November 16, 2020

Re: San Jose Flea Market Planned Development Rezoning Project Draft Environmental Impact Report

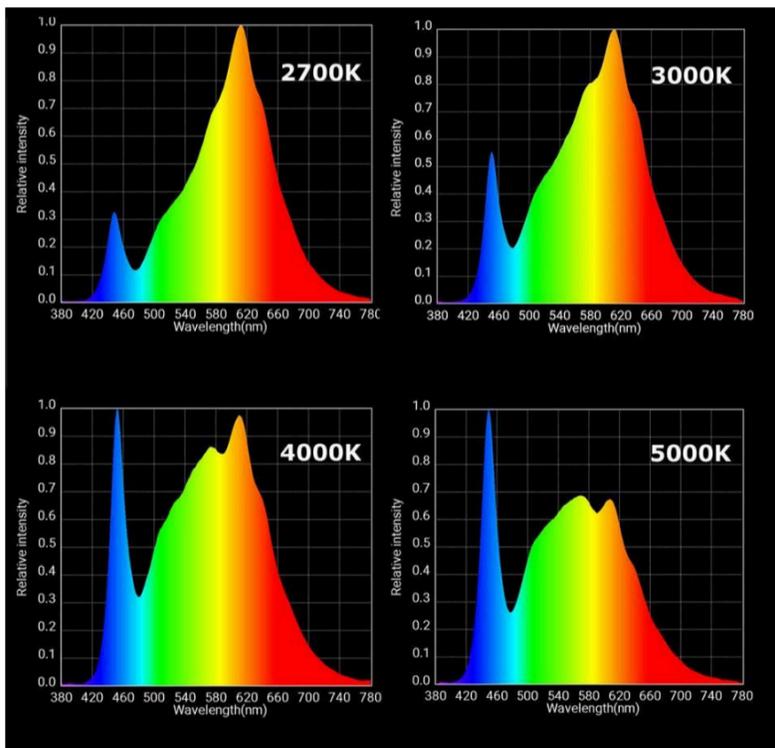
LED emits a spike of blue wavelength light, which is more pronounced at temperature higher than 2700K.

Probably the most important criteria for lighting is color temperature. This is important because LED lighting emits a pronounced peak of blue wavelength light. Research has shown that Blue light is the most damaging to circadian rhythms in organisms, and is one of the drivers of the "insect apocalypse"². For the entire project beyond the 100-ft riparian corridor, light temperature should not exceed 3000K.
